123 – 125 Liverpool Road, Manchester. Listed Building Methodology. Condition 18 – Ceilings and Cornice

This note seeks discharge of Condition 18 of the consent (Listed Building Consent reference 137547/LO/2023 regarding the installation of the new ceilings (lath and plaster), under-drawing, cornices.

Title	
CT-01 Revised Proposal	
Drawing No.	Revision
1073-TGA-XX-ZZ-DR-A-95095	P01
Status	Scale
Planning	1 : 5@A1
Project	Client
Liverpool Road	DOMIS Construction

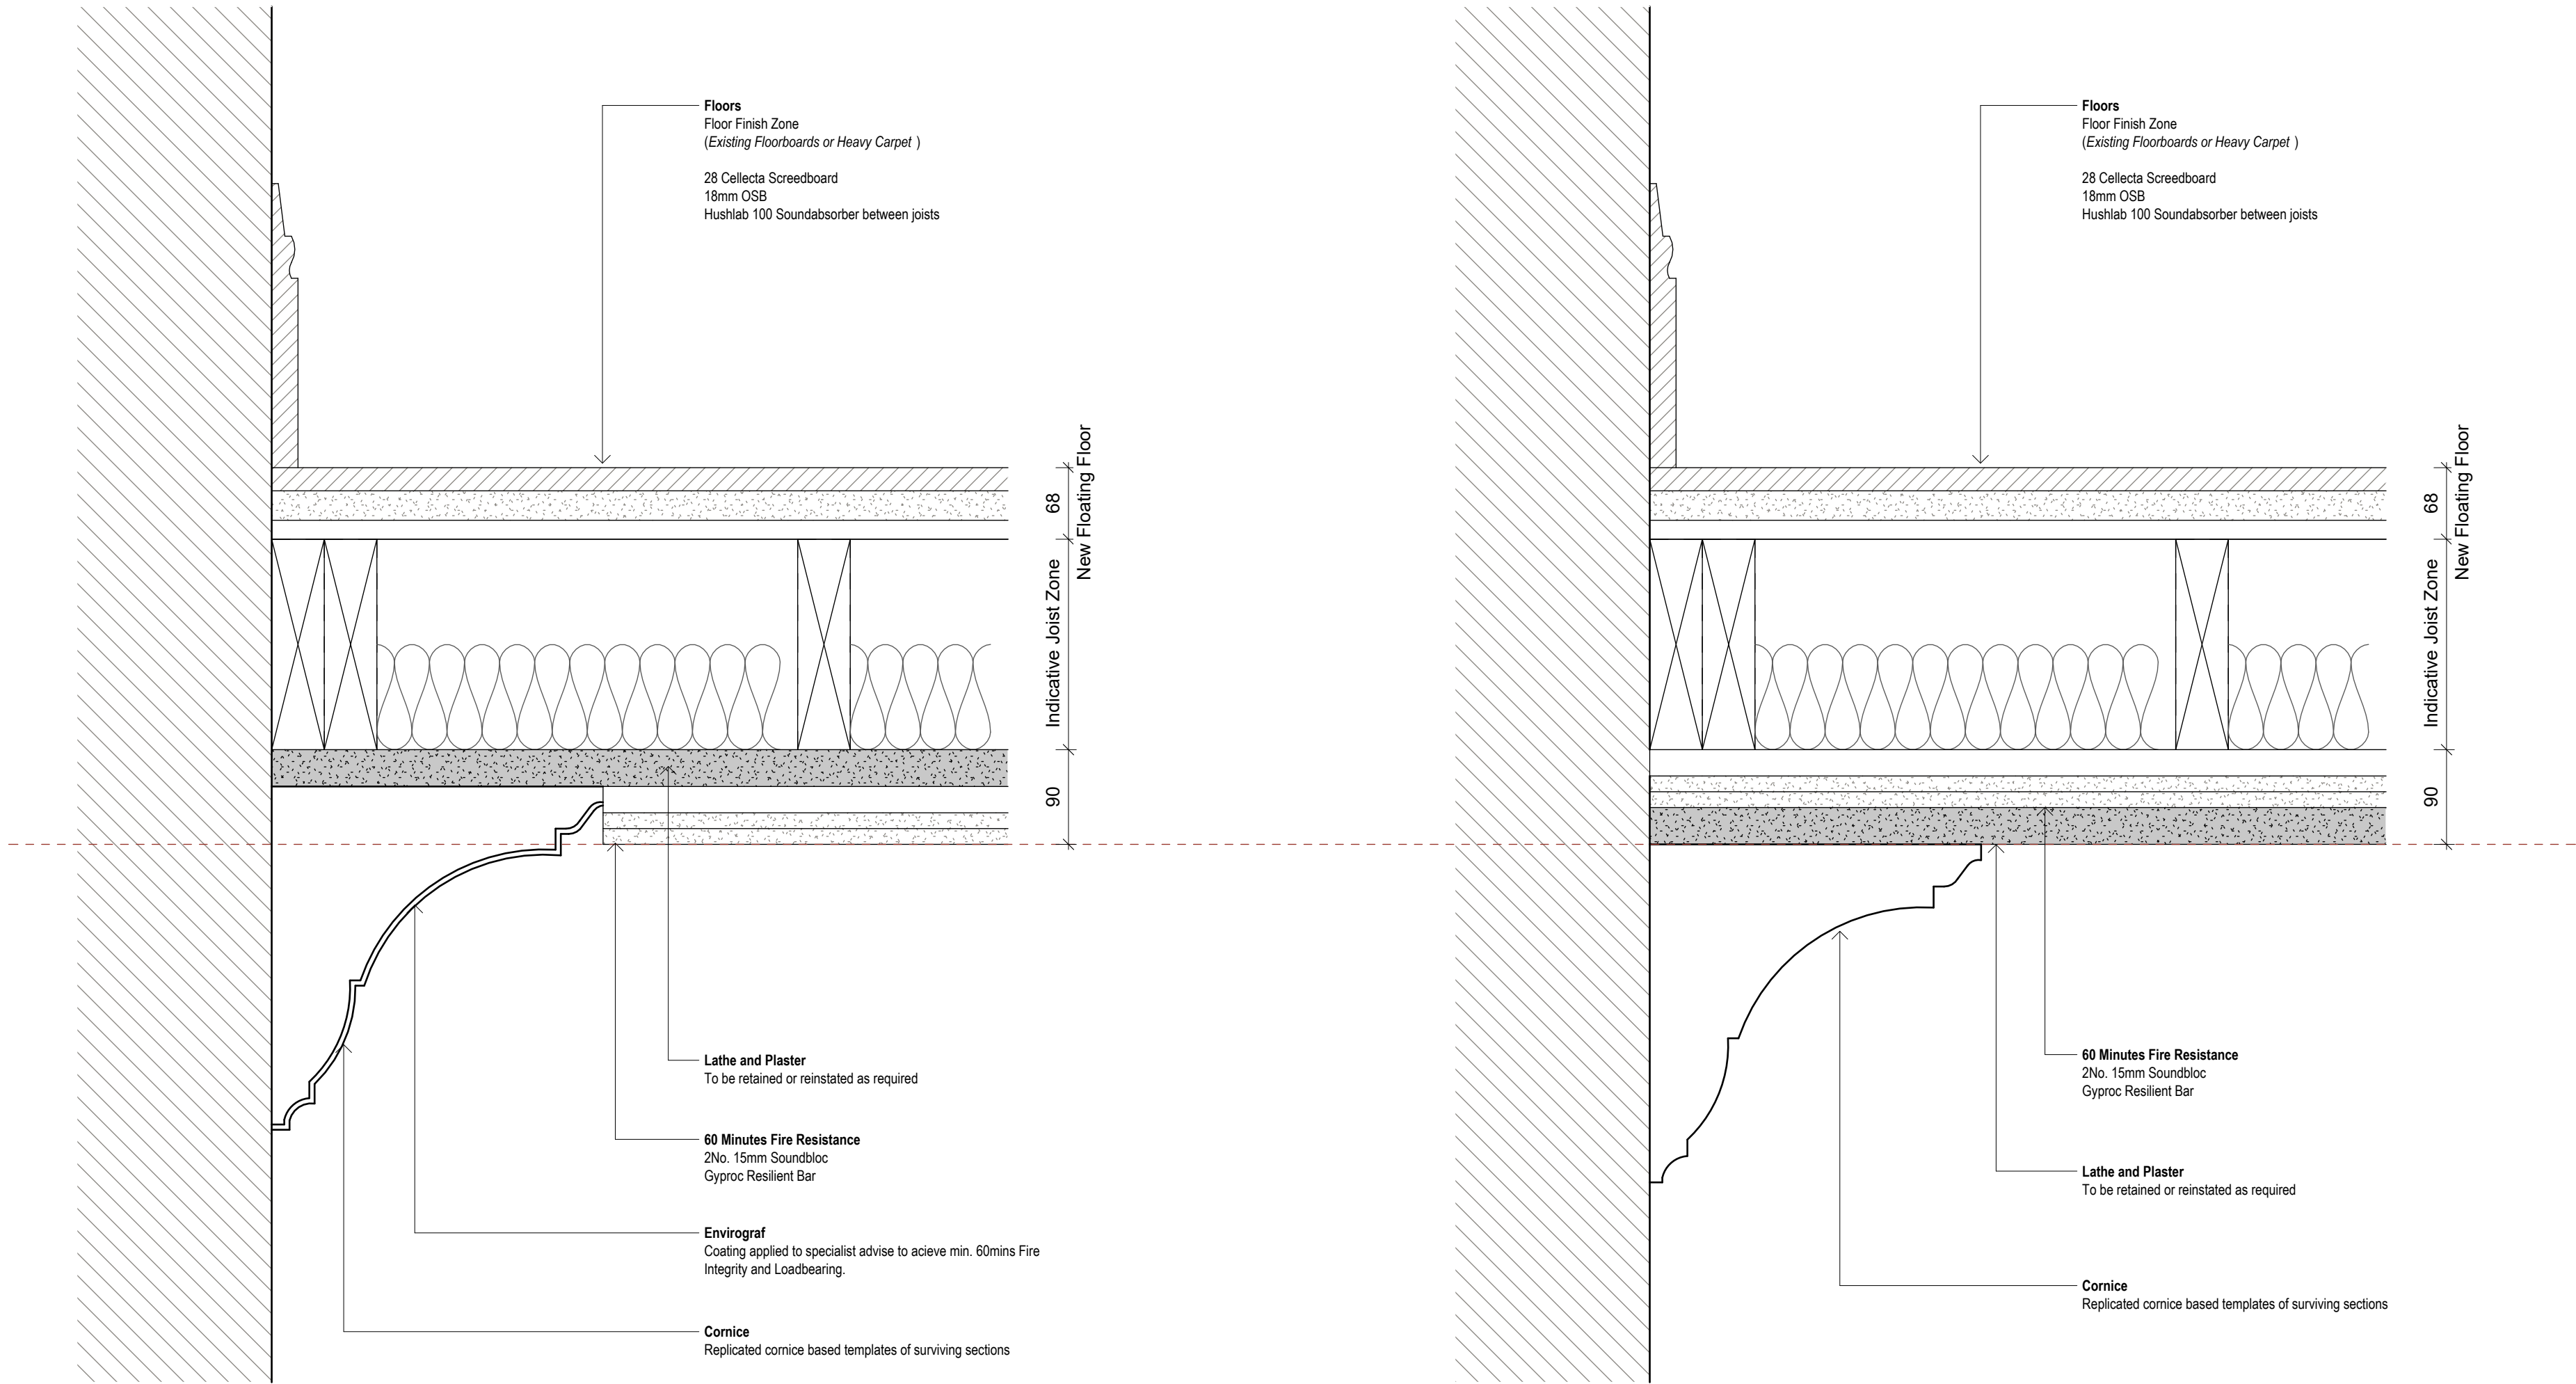
Instead of attaching new lath and plaster to the underside of the existing joists and then under drawing this with new fire line board, it is now proposed to reverse this by first attaching the fire line board to the underside of the floor joists and then fix new lath & plaster (25mm over all depth) to the board with replicas of the original cornicing attached to the underside.

It is considered that by reversing the consented proposal for the ceilings it will allow for each new lath and plaster ceiling to be fully visible within each room affected, and thus restore the original appearance and character to each room, which in contrast to the consented scheme would have meant that every new lath and plaster ceiling would have been entirely concealed from view with new fire line boarding, which would also affect the visibility of the cornicing to each room – thus not restoring the original appearance of the rooms.

The current proposal will result in the level of new lath and plaster being marginally lower in each room to account for the depth of the fire line board between it and the joists, and will also result in the level of the new cornice to also be at the same lower height. However, these minor alterations in level will be entirely imperceptible when viewed within each room and will not result in any adverse visual impact, as seen resulting with the consented proposal.

Typical Floor & Ceiling Detail (CT-01)
Principal Rooms Only
CONSENTED PROPOSAL

Typical Floor & Ceiling Detail (CT-01)
Principal Rooms Only
REVISED PROPOSAL
